## J&T Consulting, Inc.

April 28, 2021

RE: *Prowers Aggregate Operators, LLC. – West Farm Pit – Permit No. M-2008-078  
Amendment No. 2. (AM-02)  
Adequacy Review #2 Response*

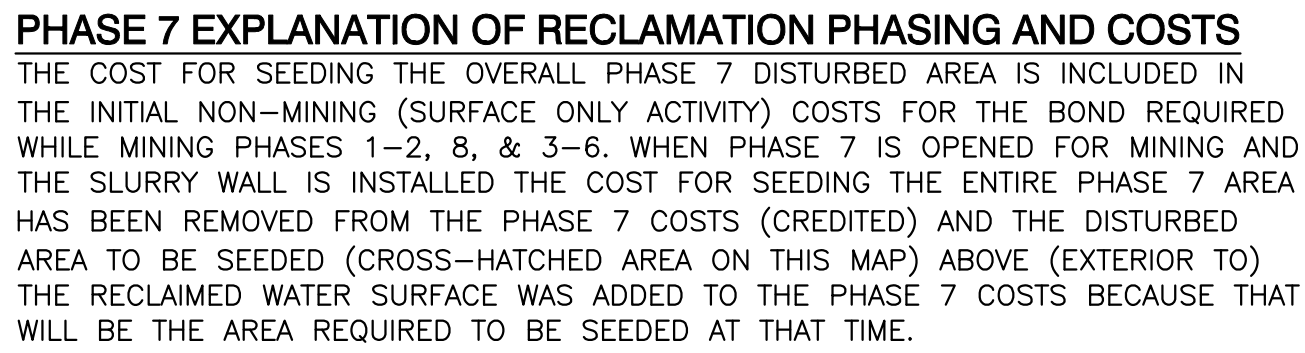
- 29) The acres recorded on the Reclamation Cost Summary chart are not consistent with the Summary of Unit Costs worksheets and acreages listed on Maps in Exhibit C. Please update the acreages for consistency.

- 30) In phases 7 & 9 acres were credited to these tasks, lowering the cost of the task. The source of the credit is labeled as 'credit from above' but it is unclear where above is. The number of acres credited is greater than the number of acres in the phase being restored. Please clarify the source of the credits and explain why the number of acres credited is greater than the acres in the phase.

**Response:** *The acreages have been updated so they match in the summary chart and the summary of unit cost worksheets as well as the map provided for showing the acreages that are bonded for disturbance. Updated Exhibit L narrative and Exhibit L Reclamation Phasing maps are attached to show the areas of disturbance. The areas of disturbance do not match the acreage of the phases shown on the mining plan maps because the mining phase areas are the areas within the mining limits only. There are areas outside the mining limits being bonded for because they are affected areas within the permit boundary. As you review the acreages and acreage credits for the phased bonding you will see the credits do match the acreages that are bonded for initially as those are the total surface disturbance that occurs before that phase is mined. Once that phase is bonded for the slurry wall and being mined, then the surface disturbance acres go down and are credited back because the area inside the mining limit is lined and creating water storage within the slurry wall, and only the acreages above (exterior to) the water surface get revegetated. Please refer to the updated Exhibit L narrative and Exhibit L – Reclamation Phasing maps for clarifications.*

**Response:** *See Response to 29.*
